Our ref. ANSV 1605/17

Subject: serious incident occurred on the 11th of October 2017, at Montichiari Airport (Italy), to BK117D2 registration marks I-BRXA. ANSV safety recommendations.

3. Safety Recommendations.

Figure 3: global overview of Helionix low RPM triggering.

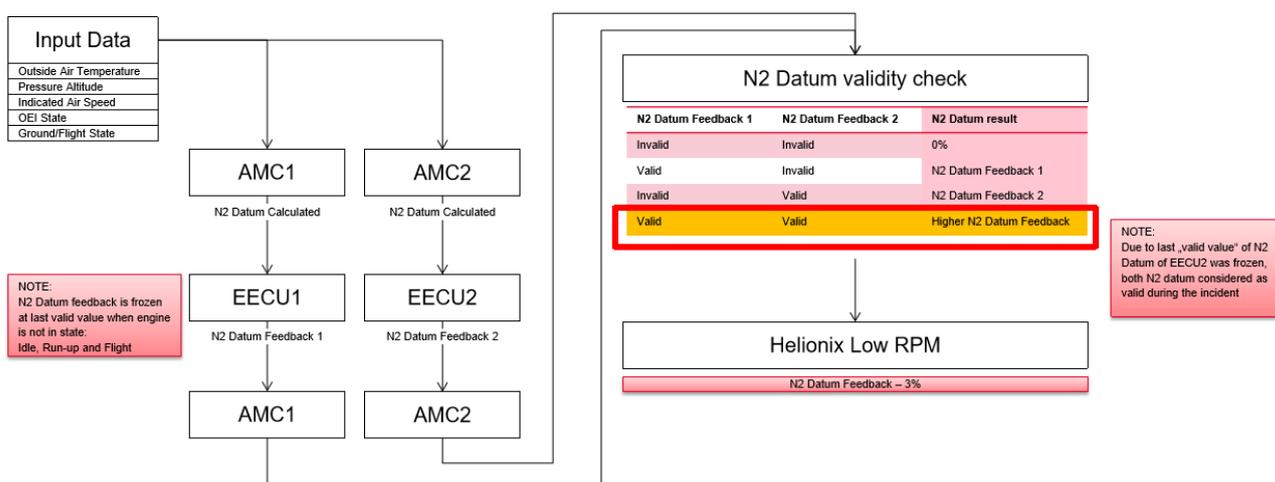
Further analysis highlighted a data handling problem between the Helionix avionic unit and the Engine Electronic Control Units (EECUs) which led to a wrong reference for the variable low rotor RPM warning, which caused the confusing indications (block diagram in figure 3): taking into account many inputs data, the AMCs provide two calculated N2 Datums (N2 is the power turbine rotation speed). These are sent to the EECUs that in turn send back to AMCs two feedback N2 Datums. Then, the N2 Datums undergo a validity check following the logic shown in figure 3. In the event flight of the BK117D2 marks I-BRXA the last valid N2 Datum value of the EECU2 was frozen and considered valid although the OEI condition was established.

Motivation: in the serious incident flight, during descent for an emergency landing in OEI condition, the crew of the BK117D2 marks I-BRXA received the main rotor “low RPM” indication (audio and visual). Subsequent technical activities demonstrated the remaining in function engine (N°1) behavior was correct as well as the the main rotor speed in relation to flight conditions in OEI. It was ascertained that the “low RPM” indication was not meant to be triggered. This was recognized as a design issue related to the data handling between the avionic units responsible for the N2 Datum processing (N2 Datum calculated, N2 Datum feedback, N2 Datum validity check).

To verify the above explained data handling issue will be solved by means of a built-in design solution, applied to all the affected helicopters, allowing in every flight condition, including in OEI, the correct processing of the N2 Datum by all the involved avionic units.

To verify that, in the meantime a design fix of the above explained data handling issue will be applied to all the affected helicopters, the crew operating the BK117D2 will be quickly informed that in OEI condition a misleading and false “low RPM” indication (audio and visual) can be received.

To verify that, in the meantime a design fix of the above explained data handling issue will be applied to all the affected helicopters, a detailed procedure will be quickly provided to the crew in order to clarify how to deal with a “low RPM” indication (audio and visual) during OEI condition. This procedure has to allow a rapid and reliable evaluation of the “low RPM” indication trustworthiness.
